# Improved Technical Specifications

## Quad Cities Station

Volume 6:  
Section 3.6; ITS Bases, and  
CTS Markup/DOC's

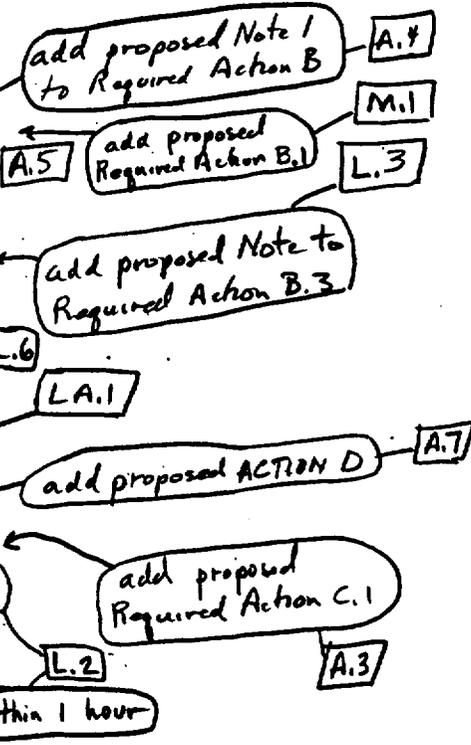
ACTION D

2. With the primary containment air lock interlock mechanism inoperable, restore the air lock interlock mechanism to OPERABLE status within 24 hours, or lock at least one air lock door closed and verify that the door is locked closed at least once per 31 days. Personnel entry and exit through the airlock is permitted provided one OPERABLE air lock door remains locked closed at all times and an individual is dedicated to assure that both air lock doors are not opened simultaneously.

ACTION B
